|  | | I-94 Monticello to Clearwater Design-Build Project, S.P. 8680-173 DESIGN QUALITY PLAN | |

| NDC 007, Silver Creek Box Culvert | February 26, 2021 |

NOTICE OF DESIGN CHANGE

TO: Bill Hines
FROM: Scott Hasburgh
DATE: February 26, 2021
NDC NO.: 007
DESIGN PACKAGE: Silver Creek

SHEET SC-1
 OF 7

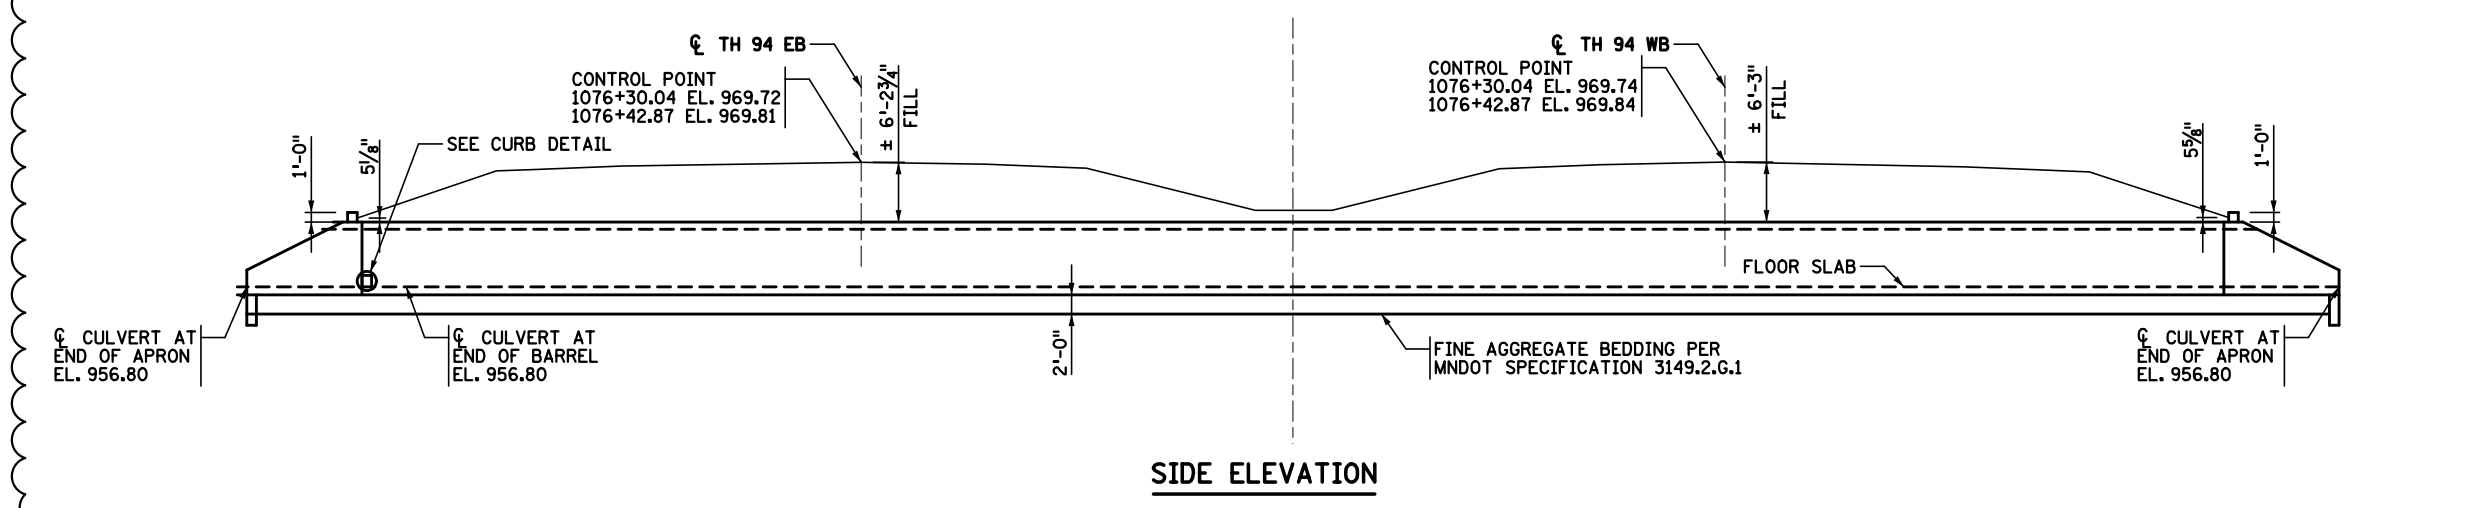
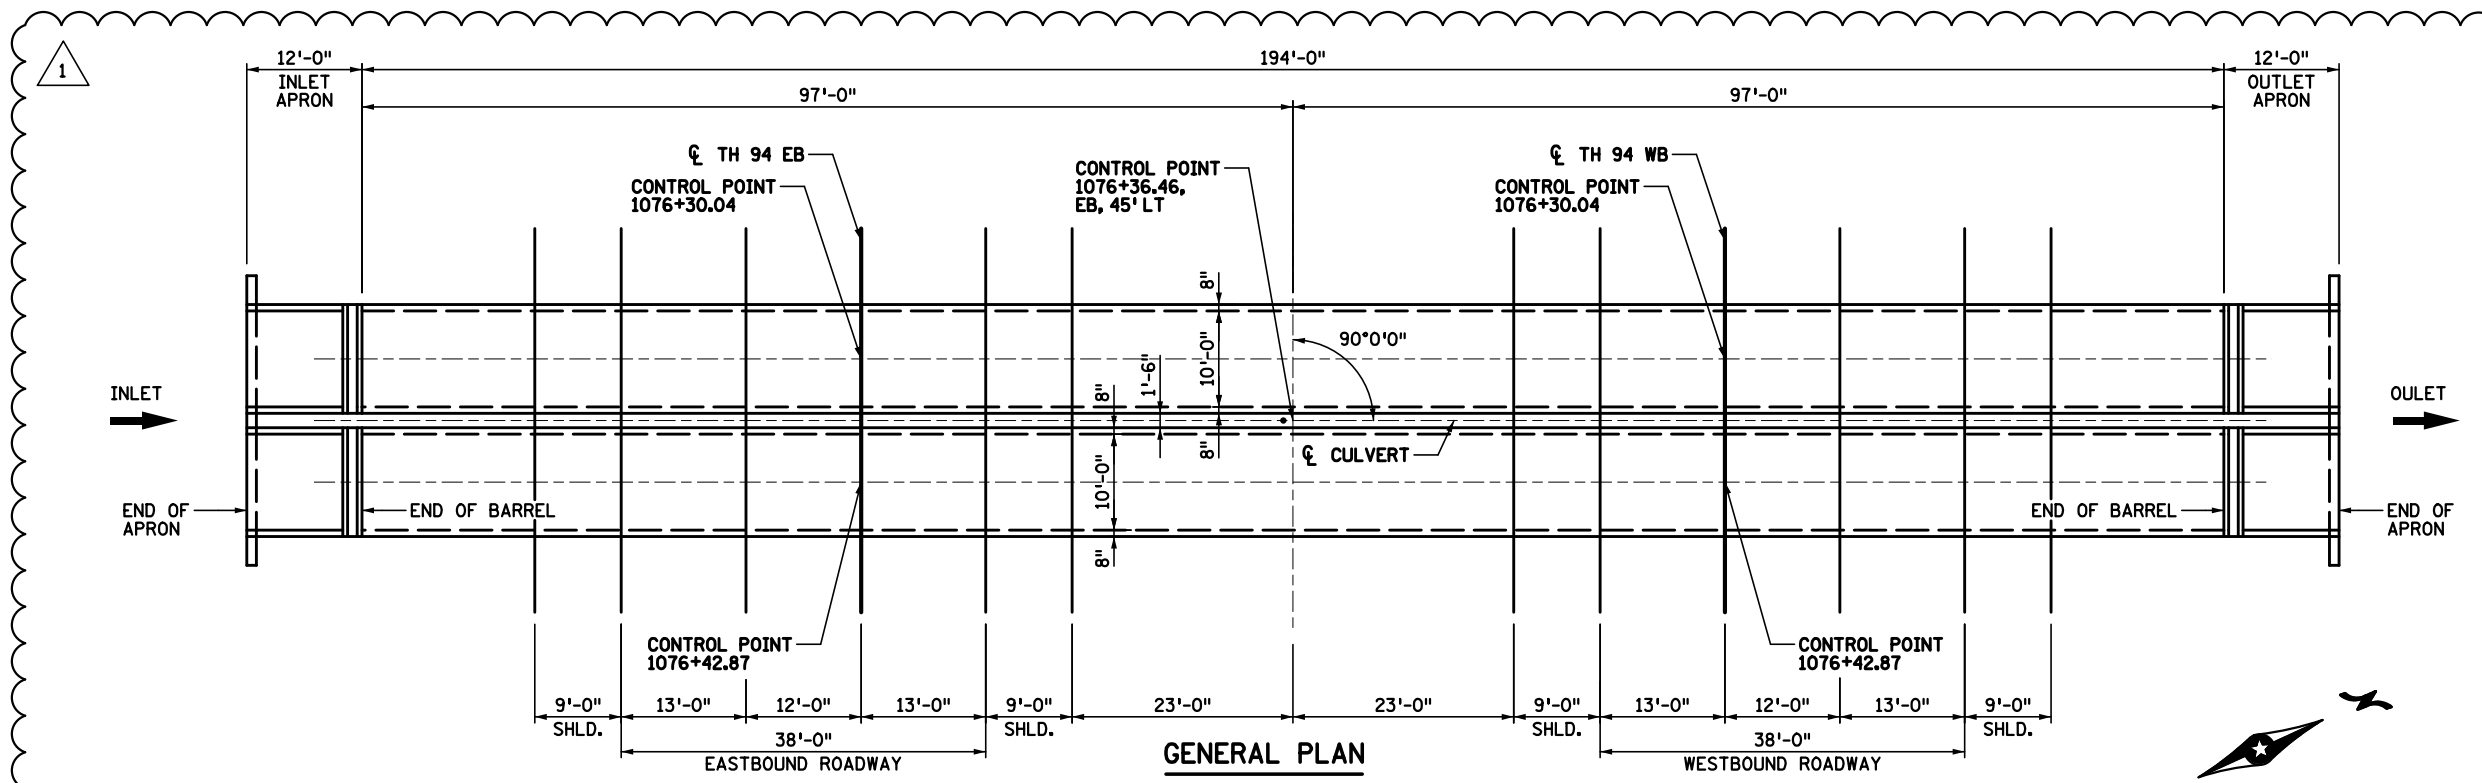
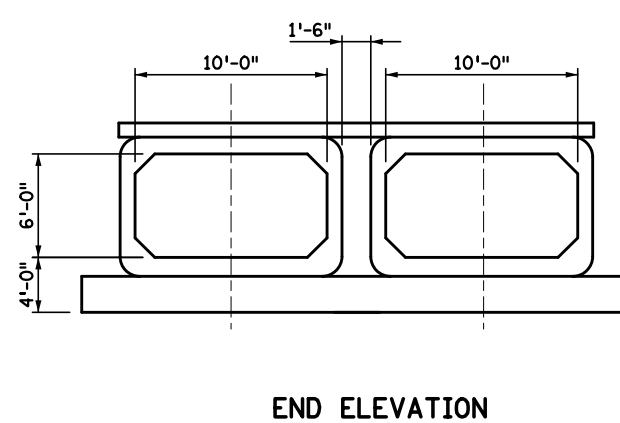
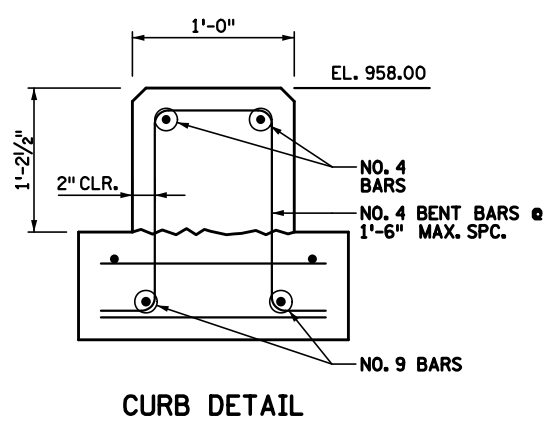
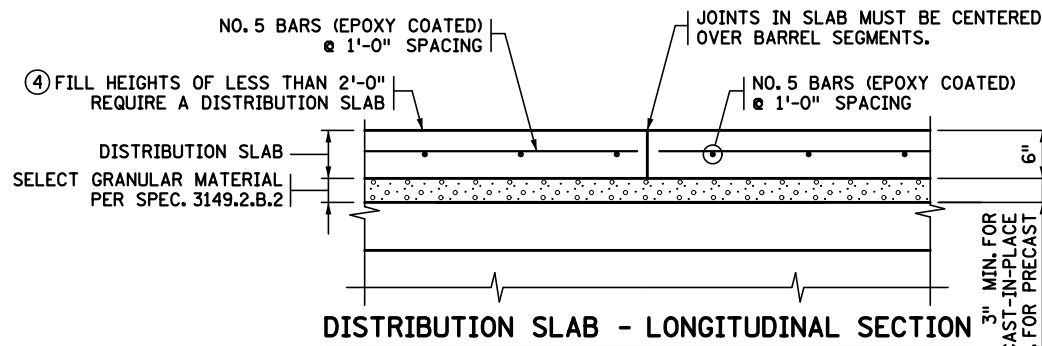
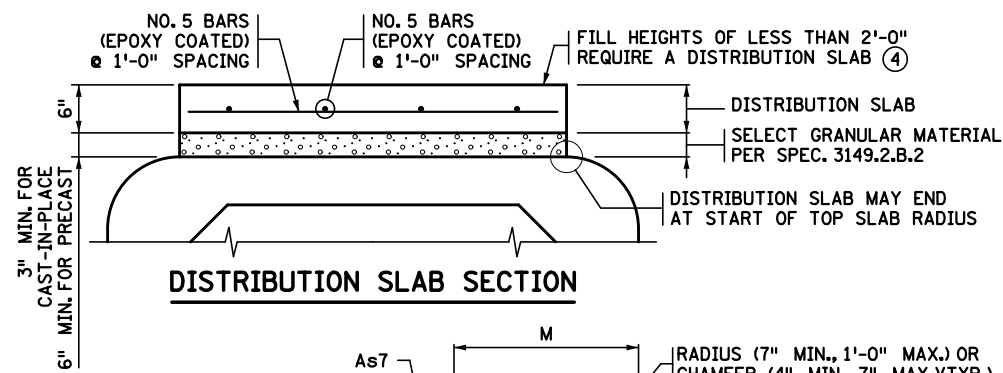
REASON FOR THE CHANGE:
 This NDC will update and provide a slightly shifted location of the Silver Creek box culvert. The depth of water and quantity of flow in the culvert make construction on existing alignment extremely difficult. Directing flow into a single cell of the existing box culvert will require installing sheet pile. The sheet pile and existing box location will leave insufficient space to remove and install the new adjacent cell of the proposed precast box culvert.

Shifting the box culvert allows better accommodation of the depth and quantity of flow away from the work zone. When the western cell is completed under I-94 WB, a temporary drainage accommodation will be installed to route drainage into the existing box under I-94 EB. The existing box culvert will then be removed under WB and the eastern cell installed under EB.

DESCRIPTION OF CHANGE:
 The box culvert will be shifted approximately 2' to the west to provide the staging necessary to accommodate the existing drainage and water level. This will allow drainage to be maintained.

| <u>Sheet</u> | <u>Description</u> |
|--------------|---------------------------|
| SC-1 to SC-7 | Moved box culvert 2' west |

| NO. | DATE | BY | CHKD | APPR | REVISION |
|-----|----------|----|------|------|---|
| 1 | 02/25/21 | NP | JW | JW | NDC 007 - SILVER CREEK CULVERT - 2' SHIFT |
